**PLANNING COMMISSION STAFF REPORT
ADMINISTRATIVE ITEM**

**PLNPCM2011-00464
O'Reilly Auto Parts
Building and Site Design Review
1122 South State Street
November 9, 2011**

O'Reilly Auto Parts is requesting a building and site design approval at 1122 South State Street to allow them to build a new auto parts retail store that would not meet the minimum first floor glass requirement along one of its street frontages, Harvard Avenue, in the Corridor Commercial (CC) zoning district and South State Street Corridor (SSSC) overlay district. The Planning Commission has final decision making authority for building and site design review.

1 SITE GRADING PLAN
C1 SCALE: 1" = 20'

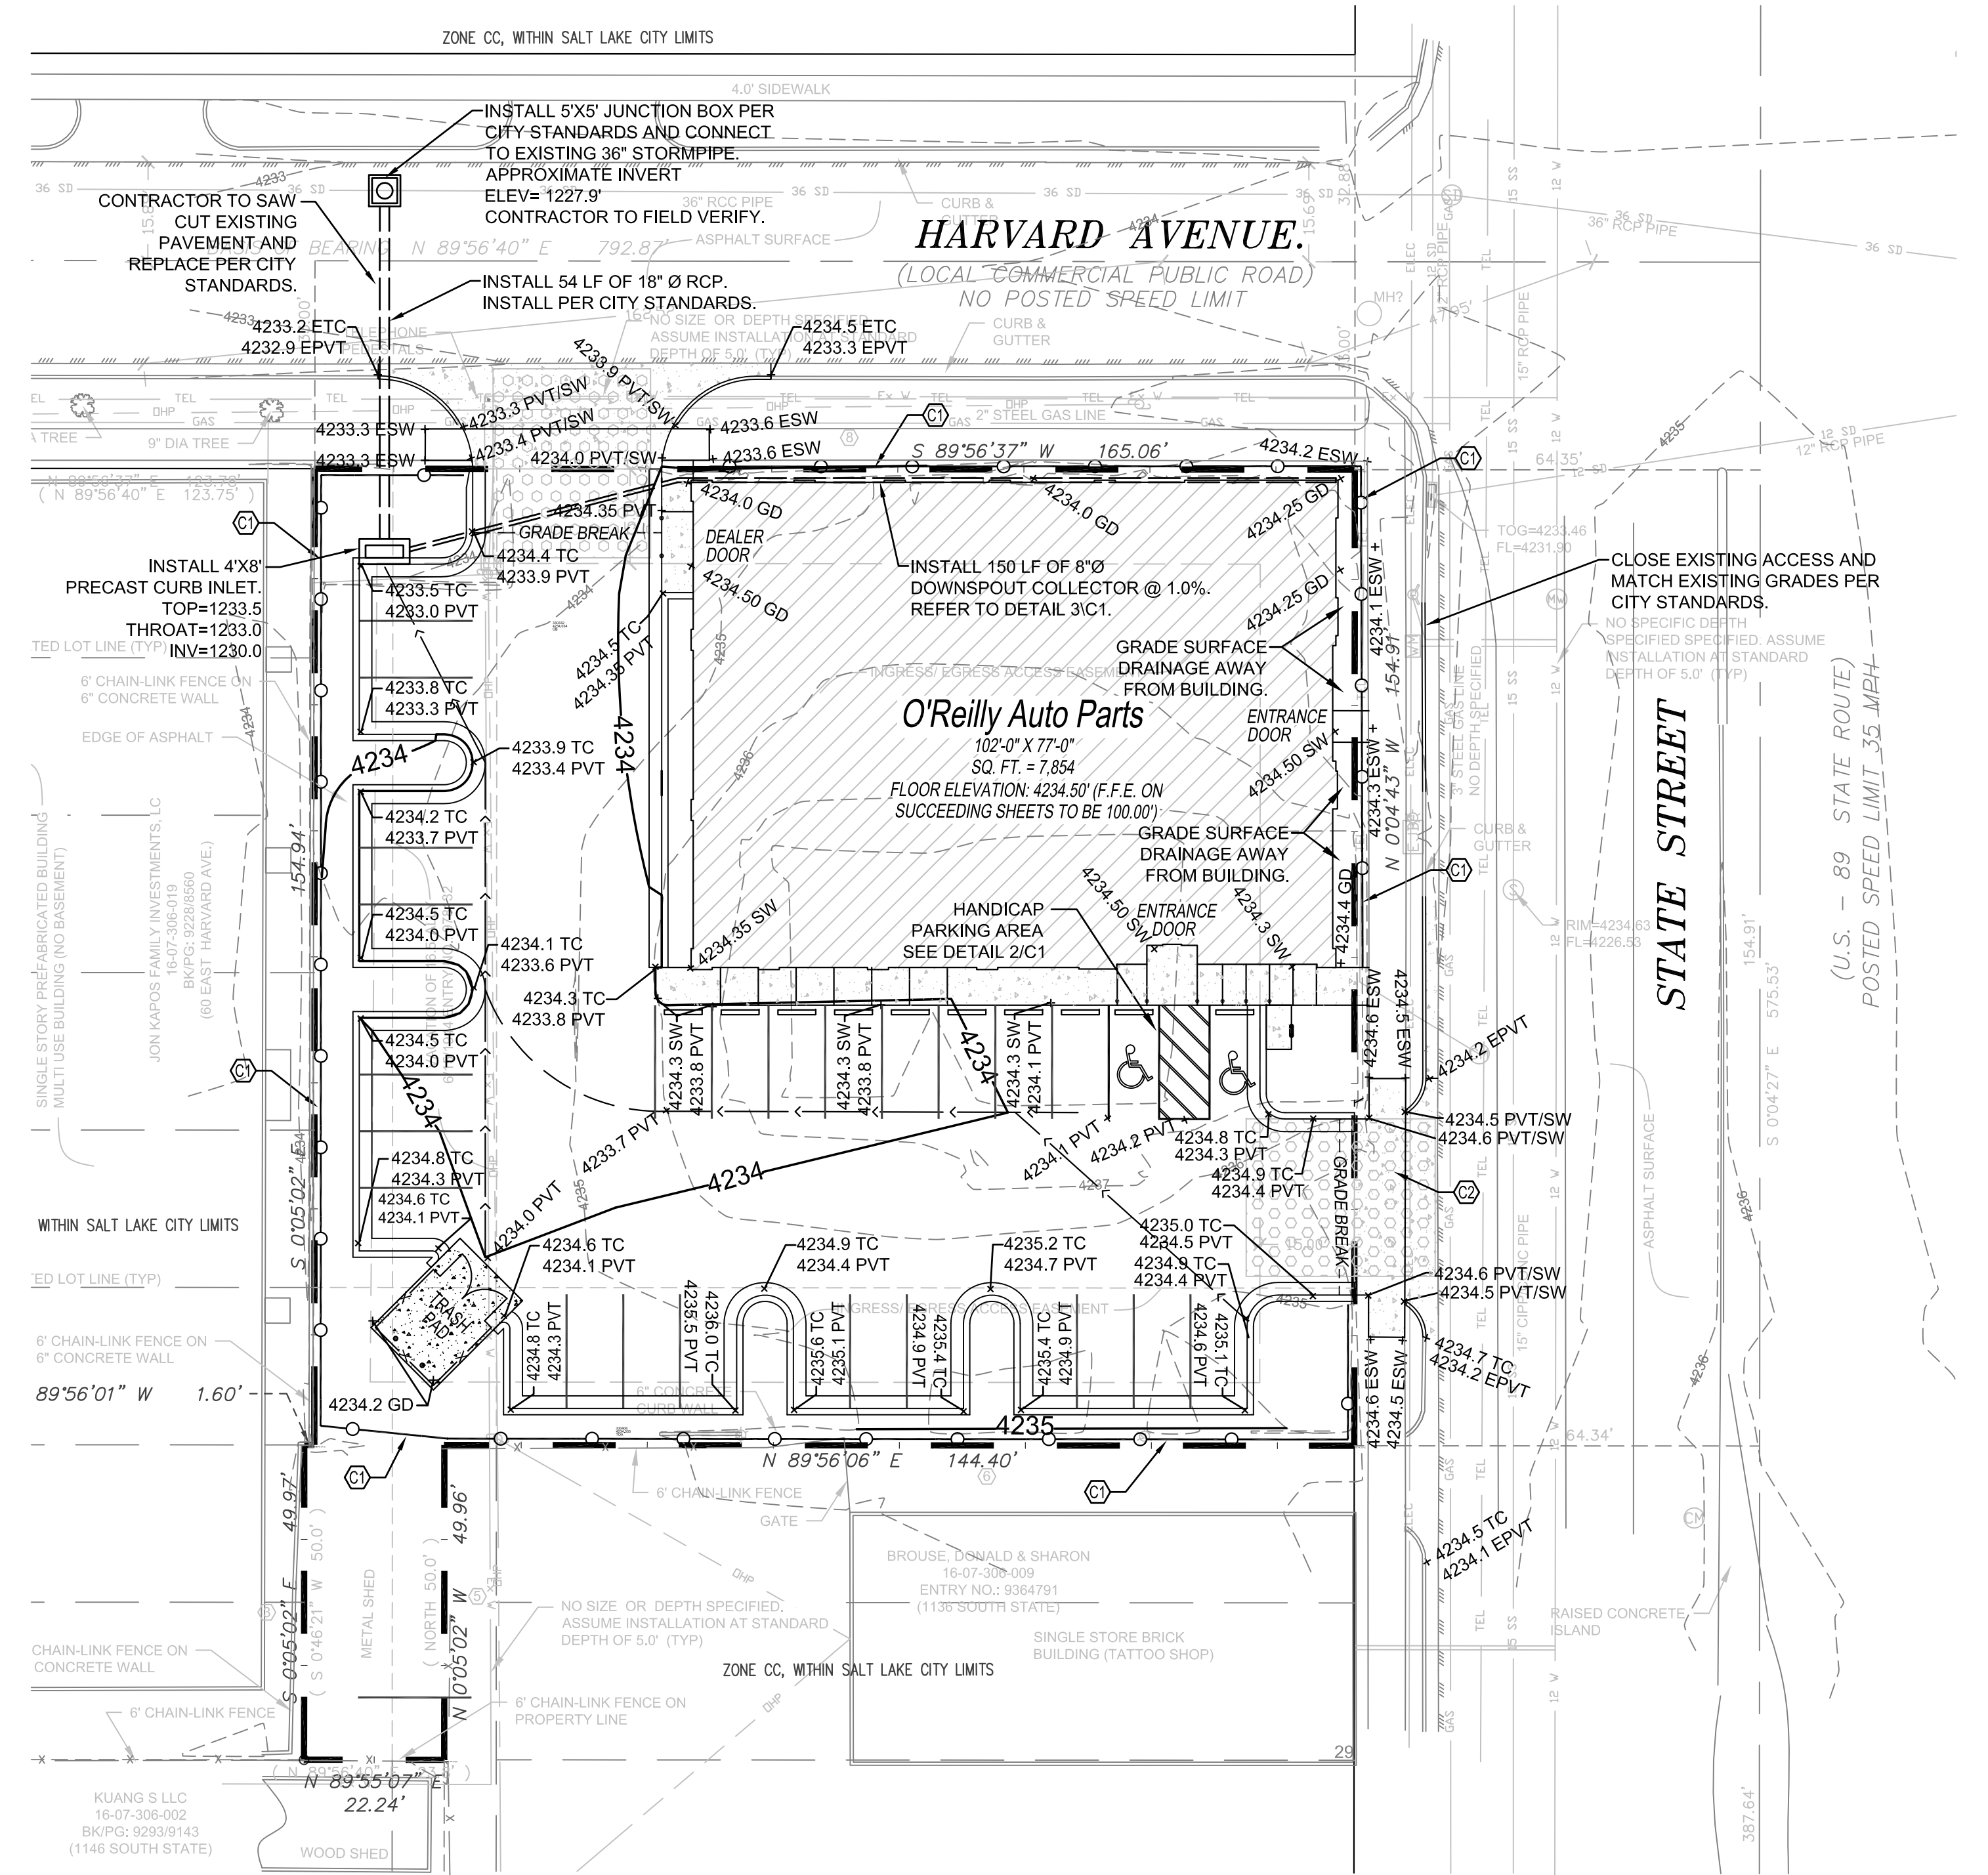
For a new drive approach to take the place of the existing cracked drive approach in Harvard Ave., some curb & gutter may be required as well. The existing dead drive approach in State Street, the existing piped drive approach in State Street, the existing paved park strip in State Street and the existing cracked sidewalk panels in State Street must be removed as part of this project. The proposed drive approach in State Street requires approval and a permit from UDOT, prior to constructing it. Prior to installing the proposed drive approach (APWA Std. Plan 225) in Harvard Ave. and new sidewalk in State Street, a Permit to Work in the Public Way must be obtained from SLC Engineering.

Demolition of the existing dead drive approach in State Street, the existing piped drive approach in State Street and the existing paved park strip in State Street was also mentioned in my previous review but a demolition plan is not included to show this. Also, some existing cracked sidewalk panels in State Street must be removed as part of this project.

1 LANDSCAPE PLAN

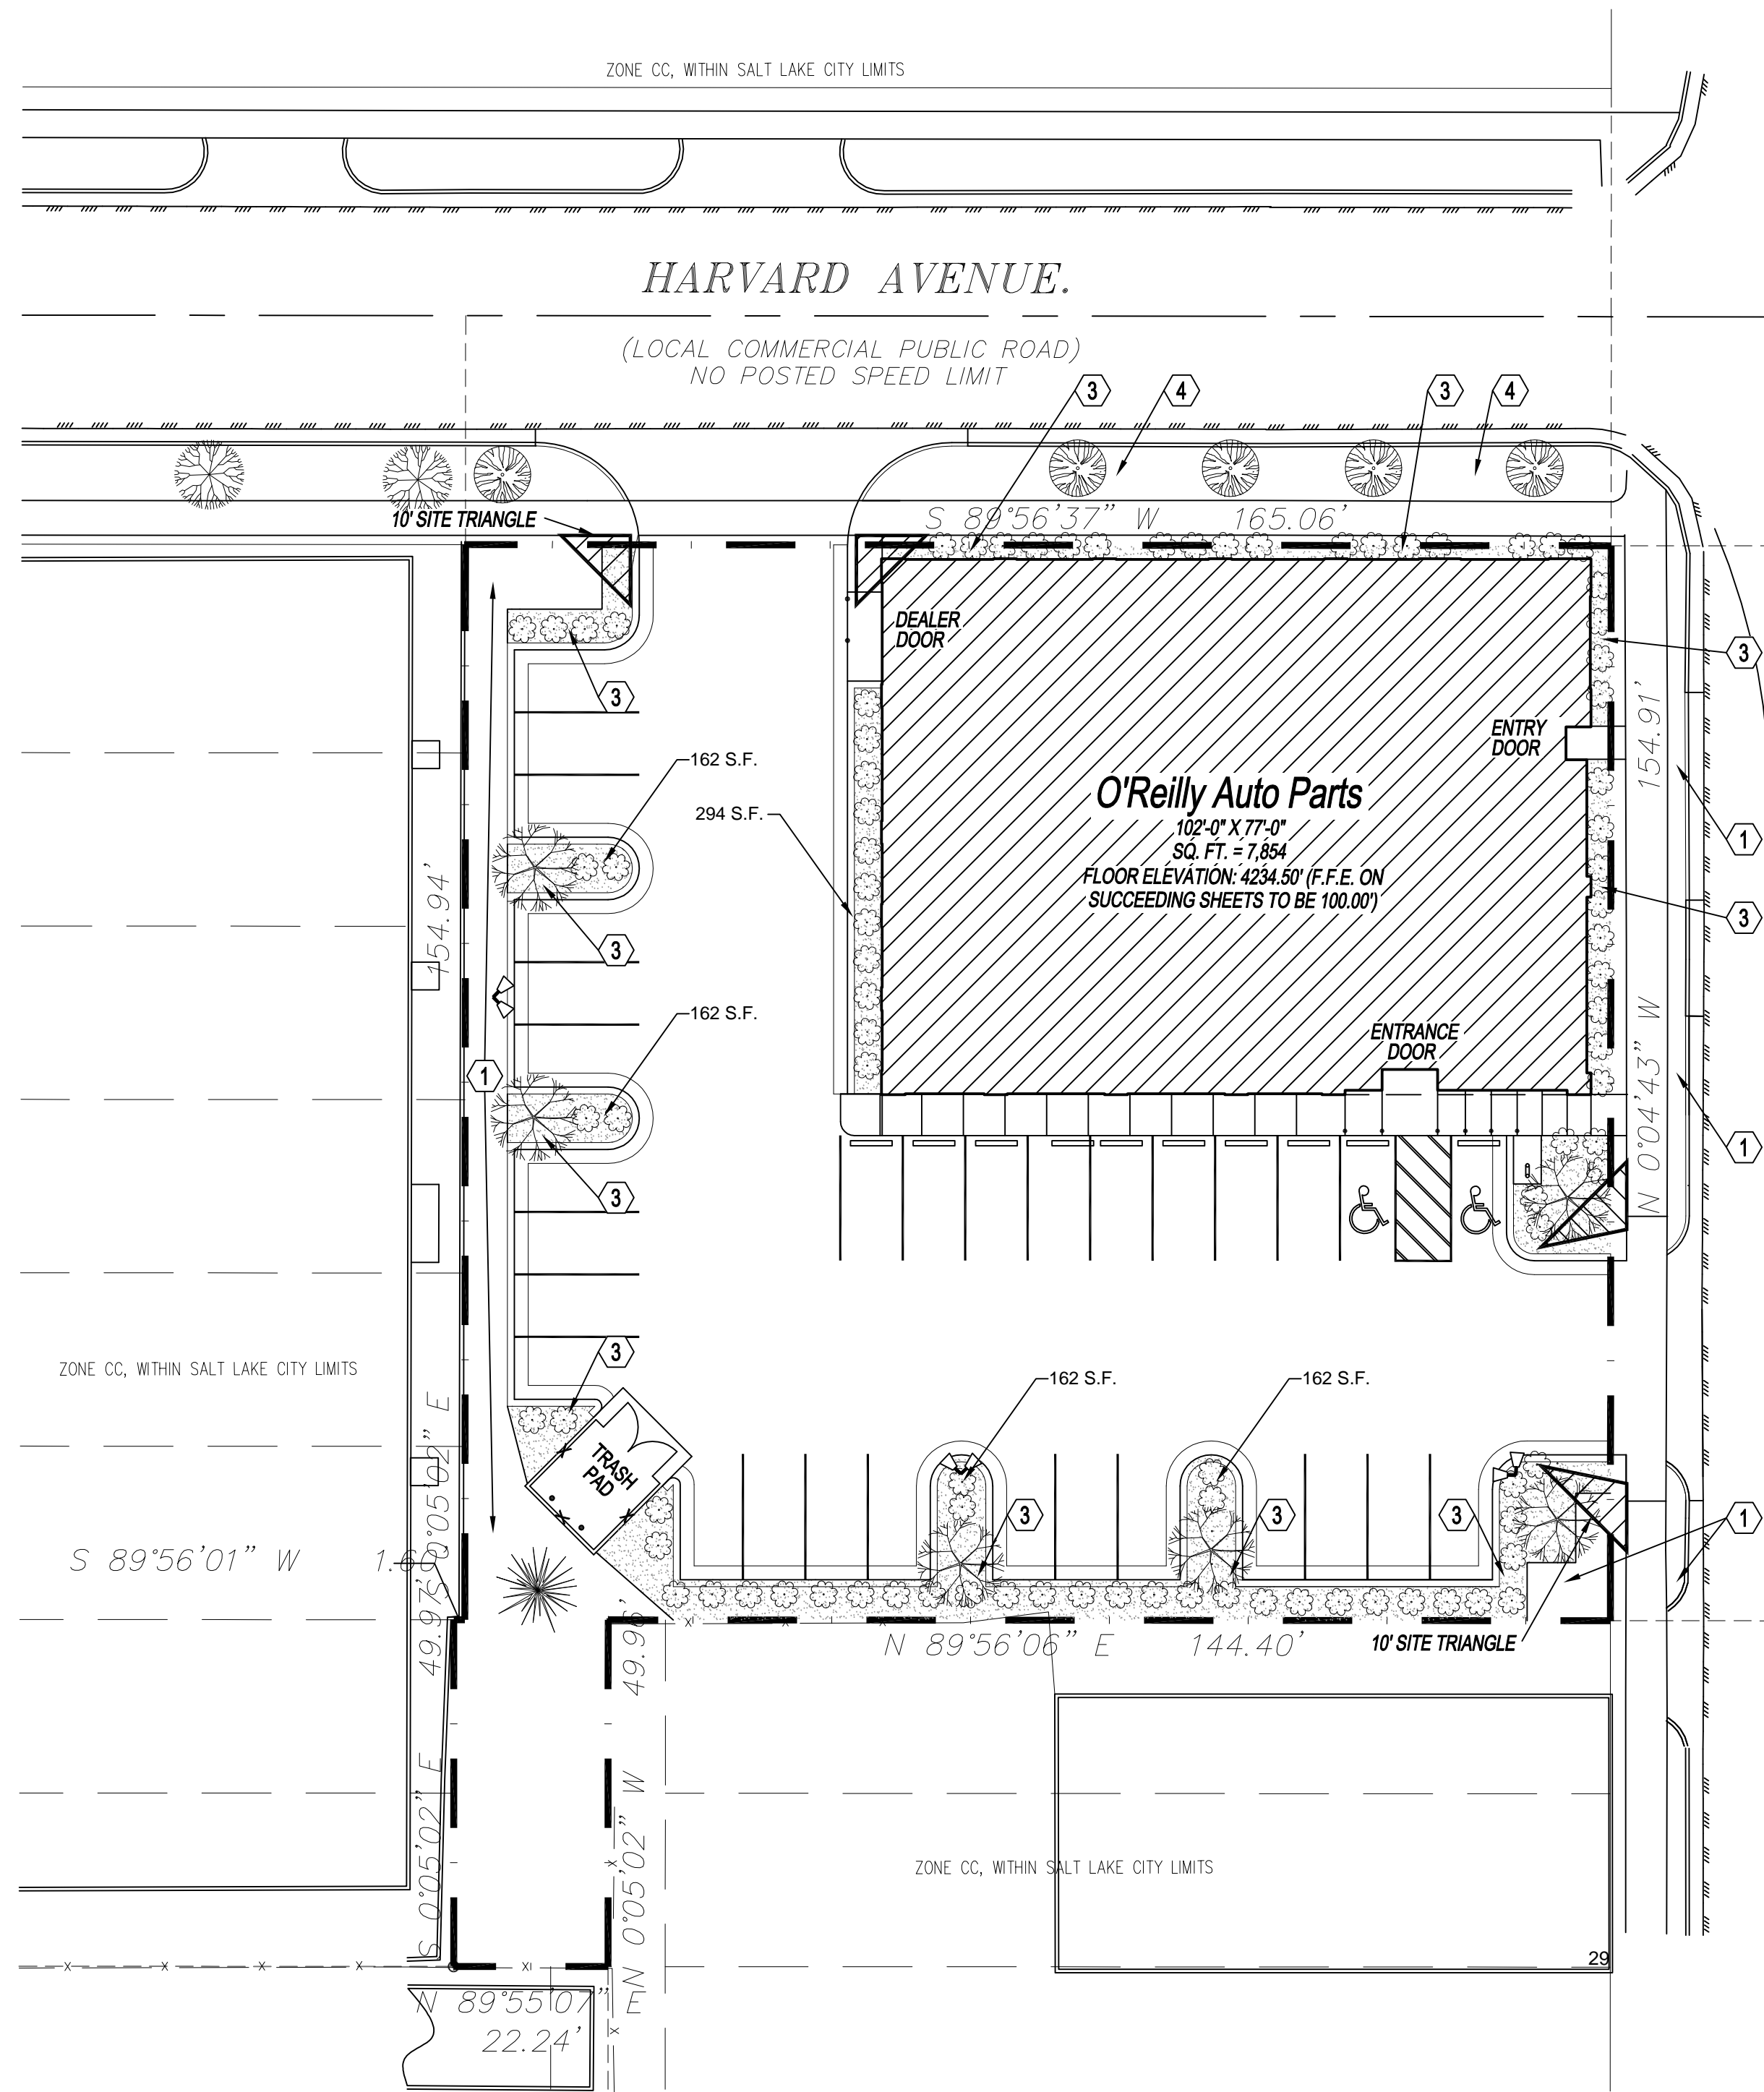
More information is required on the Landscape Plan to show how the park strips in Harvard Ave. and State Street will be irrigated and landscaped.

Although they submitted an Irrigation Plan, I don't see where the designer has addressed my previous comment regarding irrigation of the park strips. I wrote on my previous review:

More information is required on the Landscape Plan to show how the park strips in Harvard Ave. and State Street will be irrigated and landscaped.

1. How will the plantings in the park strip along Harvard be irrigated?
2. Chokeberry bushes are shown along Harvard. They do not qualify as street trees. One street tree is required per 30 feet of street frontage.
3. As noted previously, a sidewalk should be provided along the rear of the building to provide a pathway from parking spots at the rear of the property to the building's entrances.
